STAFF REPORT

TO: Planning and Zoning Commission
FROM: Brad Scheib and Trey Rouse, City Planning Consultants
DATE: June 8th, 2022
SUBJECT: Vail Property Comprehensive Plan Amendment, Rezoning, and Preliminary Plat
APPLICANT: City of Kasson
OWNER: City of Kasson
LOCATION: Vail Property Subdivision – 59+- AC THE EAST 100 ACRES OF THE SOUTHEAST QUARTER (SE 1/4) OF, Kasson MN
MEETING DATE: June 13th, 2022
COMPREHENSIVE PLAN: Medium Density Residential
ZONING: D-H Development Holding

VAIL SUBDIVISION

PRELIMINARY PLAT

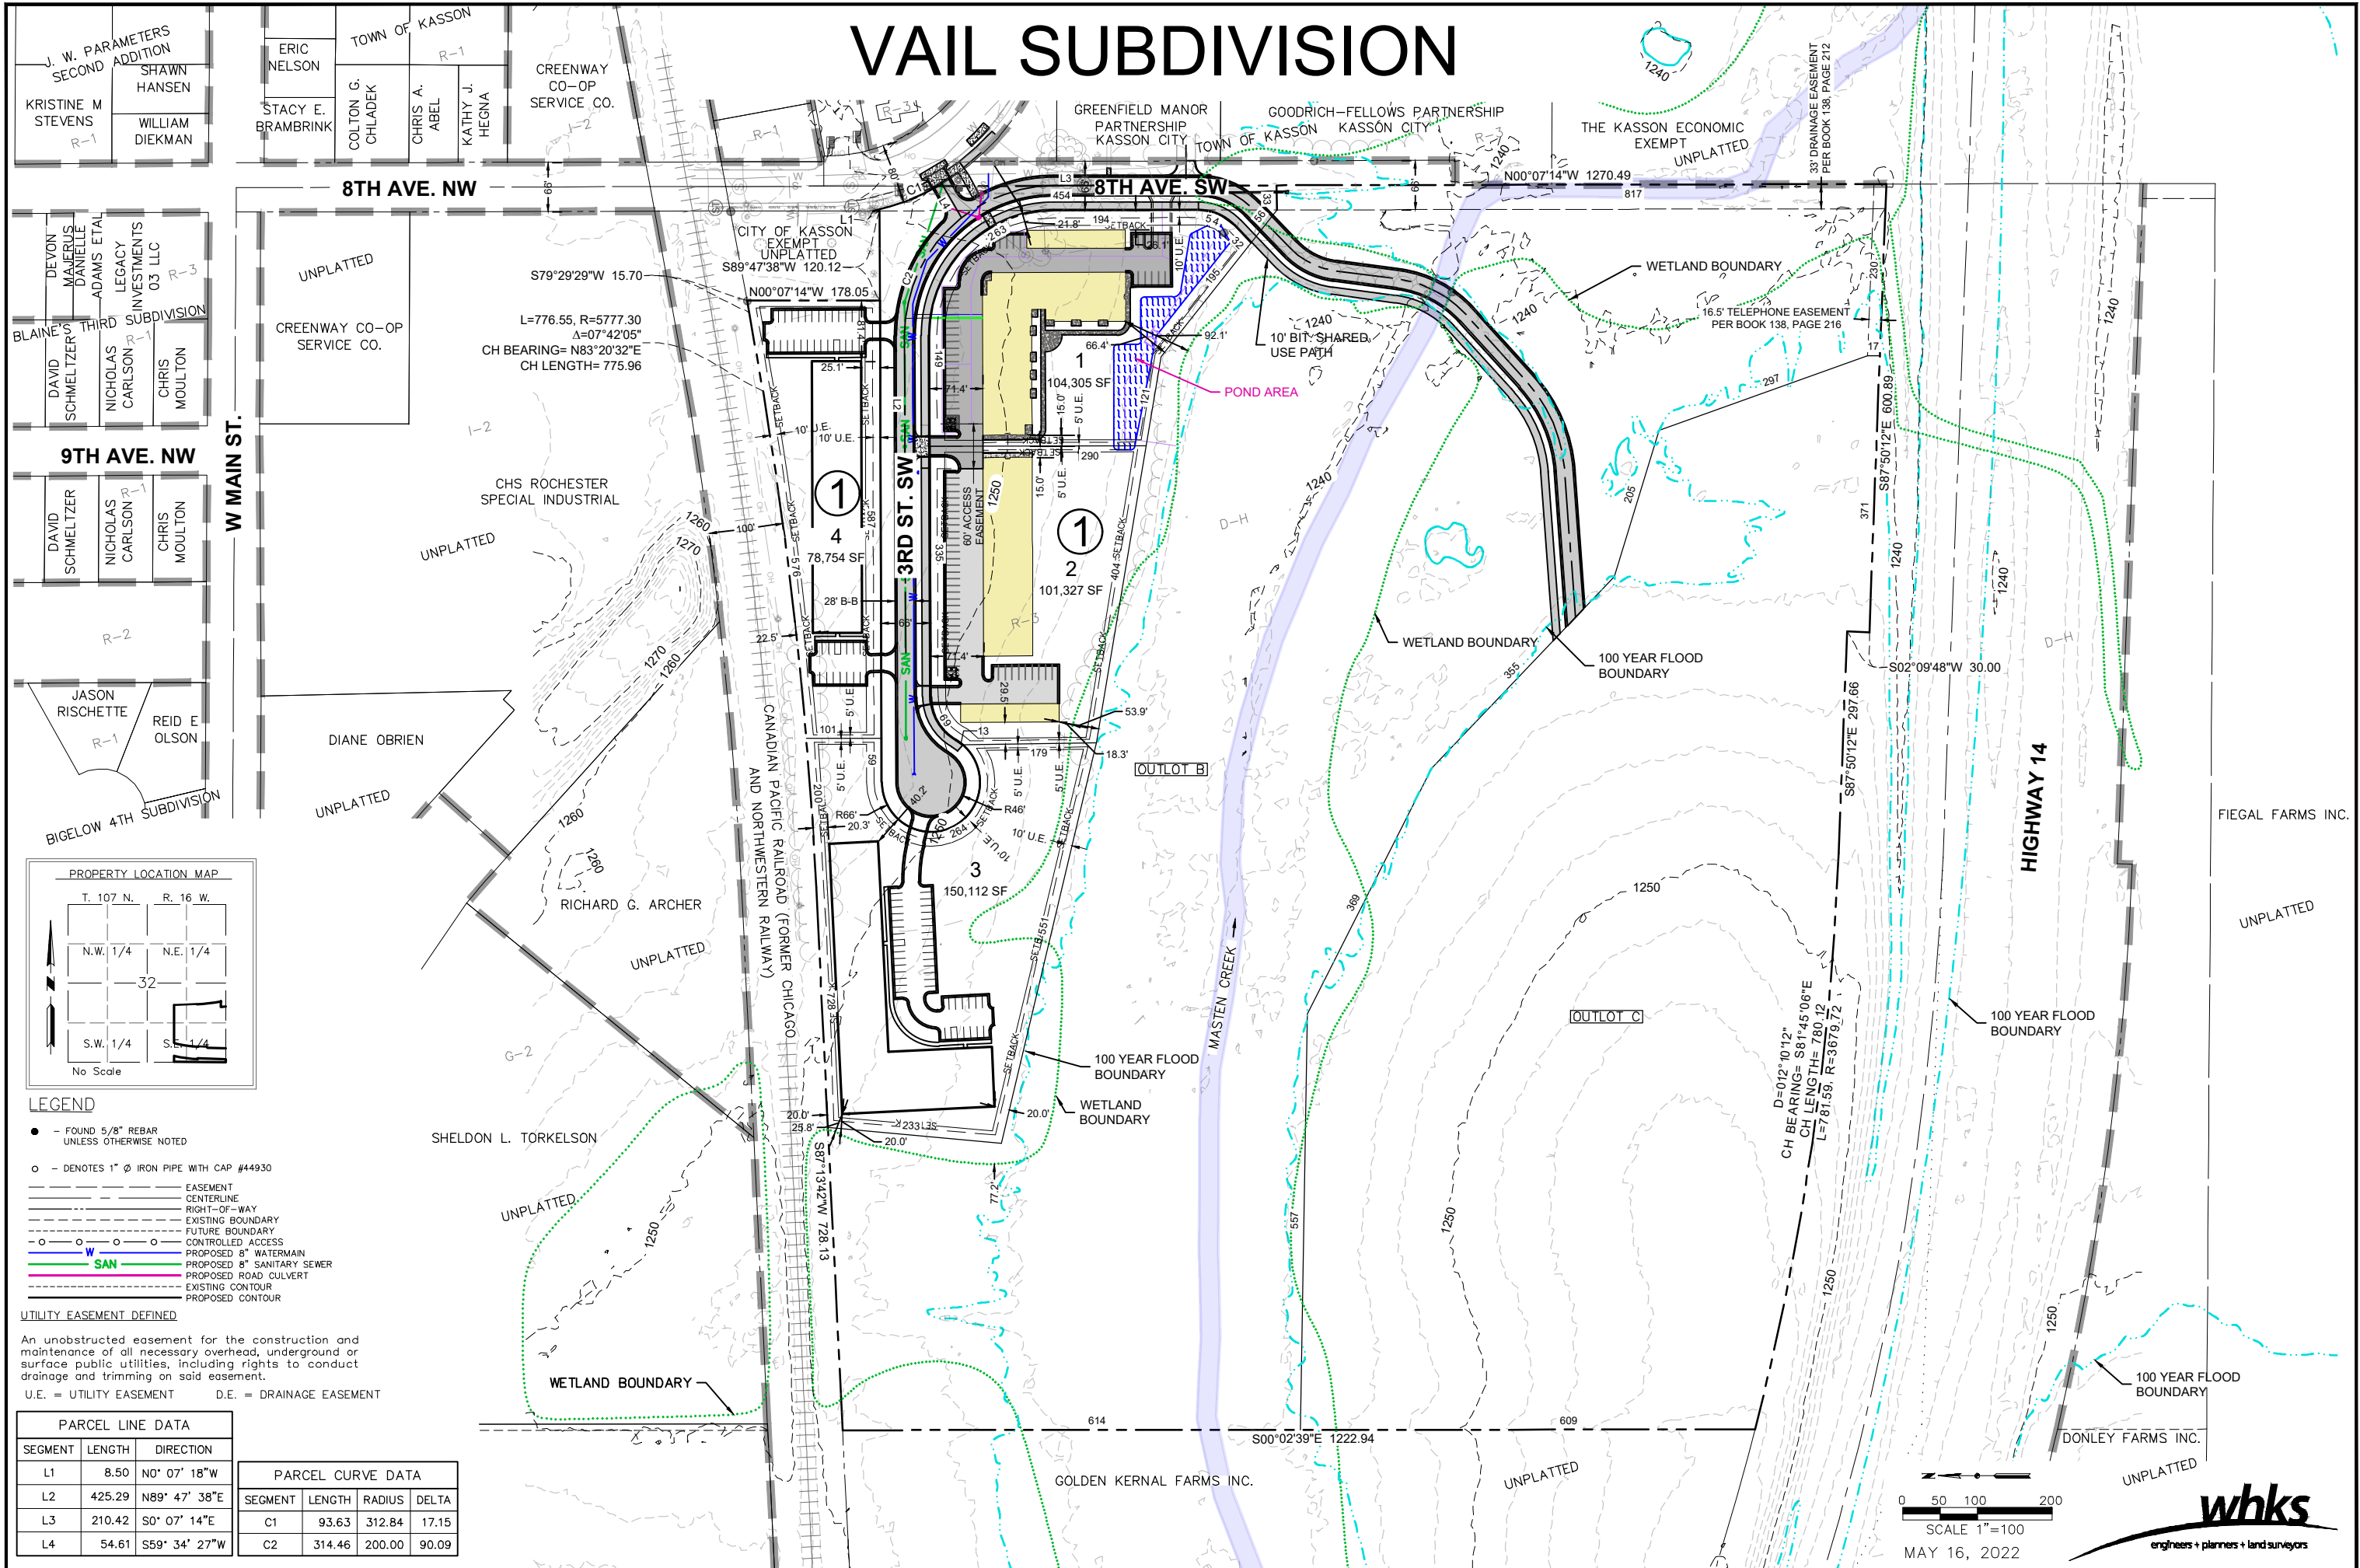
Side yard – internal side yards are established with a minimum setback in the proposed PUD of 15 feet (see lots 1 and 2.) This is consistent with R-3 standards so no flexibility is requested.

Rear yard – internal rear yard setbacks in the proposed PUD are established with a minimum setback of 20 feet see lot 3). Flexibility is requested from the R-3 rear yard setback standard of 25 feet to a minimum of 20 feet.

Front yard – Front yard setbacks as proposed have a minimum setback of 21 feet 8 inches (see lot 1). This is as measured from the detached accessory structure. This standard is a deviation from the R-3 front yard setback of 25 feet. Flexibility of the front yard setback standard is requested for the easterly lot frontage of Lot 1 for a minimum setback of 21 feet 8 inches.

Parking setbacks - Section 154.295 (F) (2) of the zoning code requires parking lots to be setback a minimum of 8 feet from the property line when adjacent other residential districts. Due to the curvature of the street design, two areas of Lot 1 exceed setback requirements and are within 5.5 feet of the property line. The PUD is requesting flexibility for this standard for Lot 1 to allow the proposed parking lot to be within 5.5 feet.

Dimensions and size of all lots 1-4 meet the requirements of the R-3 District for lot dimensions. Section 153.140 of the Subdivision ordinance limits the length of a block to 800 feet and generally discourages cul-de-sacs except in circumstances where presence of natural features or other constraints limit the ability for through streets. The proposed Vail Street extends approximately 830+- feet to the west and terminates in a cul-de-sac. In this case, the presence and alignment of Masten Creek and associated floodplain/wetlands, coupled with the railroad tracks, creates a practical and environmental barrier to meeting the block length and through street standards. Extension of a street to the west has a significant impact on natural resources and requires building approximately 600 to 700 feet of public street that serves limited development potential. In addition to environment impacts, construction of such a street would be cost prohibitive. Alternatives to serve land to the west, while challenging, do exist.

Staff recommends approval of the proposed block length and use of a cul-de-sac as proposed in the preliminary plat.

EXTERIOR
ELEVATION

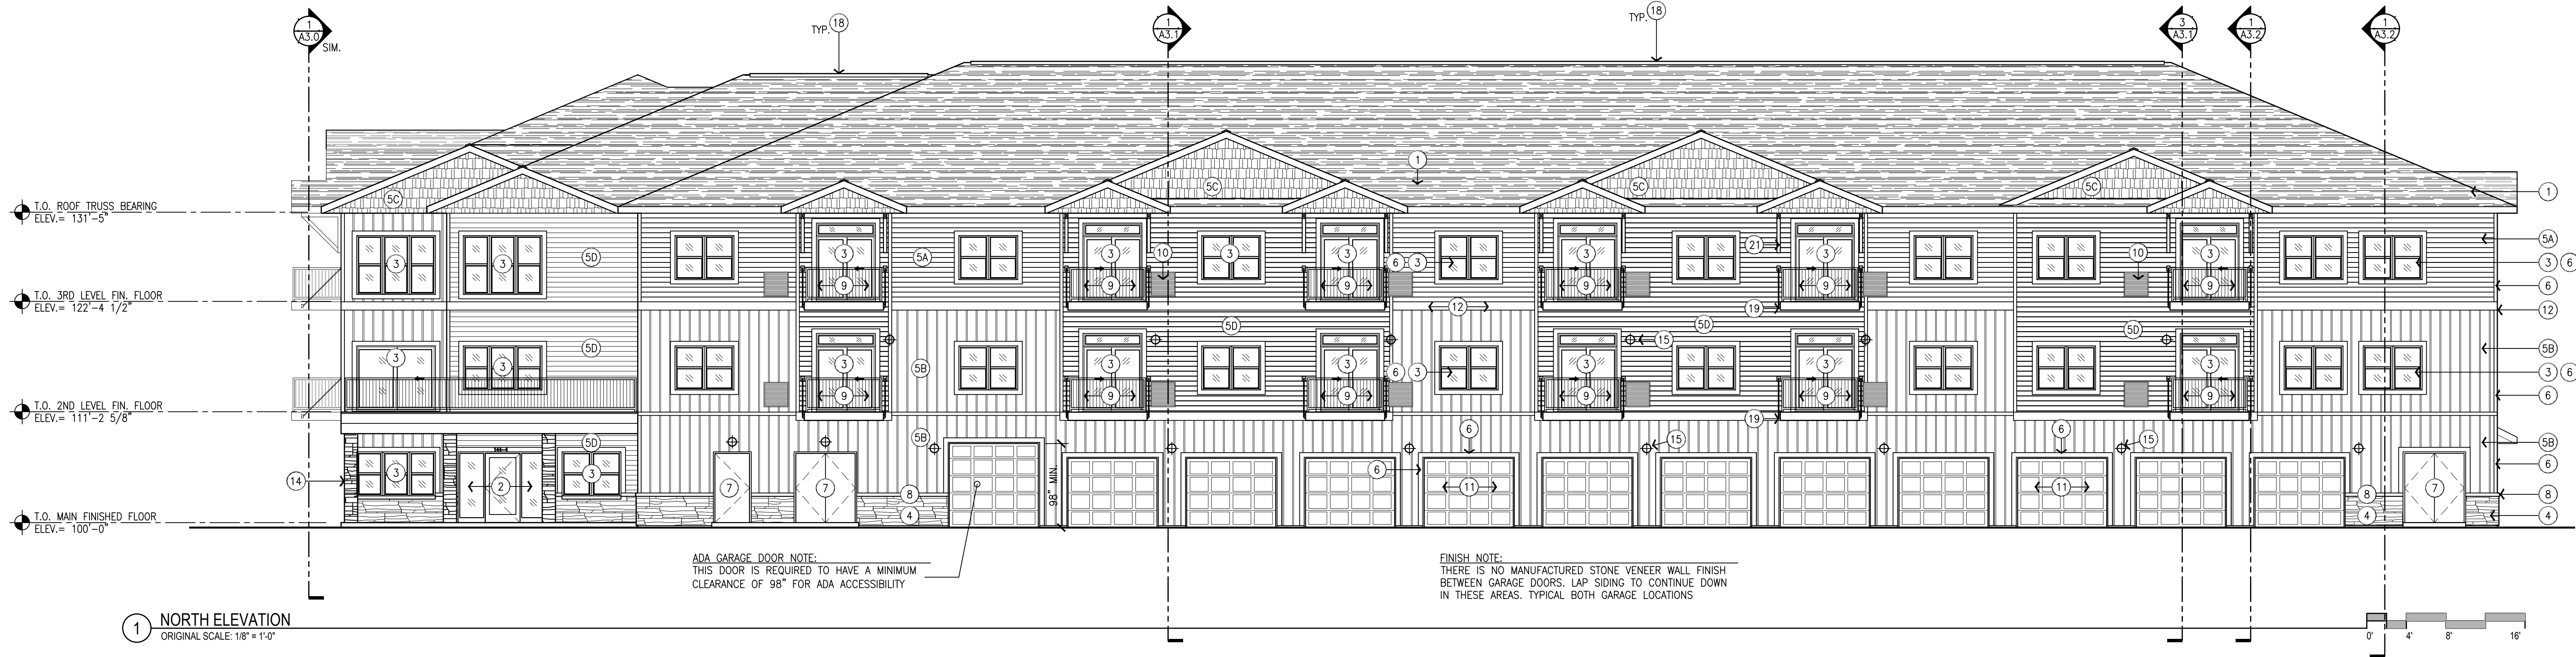
All proposed projects within the PUD are proposed to adhere to the maximum building height standard as established in the R-3 district which is 45 feet or 3.5 stories. Attached are elevations for Phase 1 as an example of how the initial proposed project adheres to that standard.
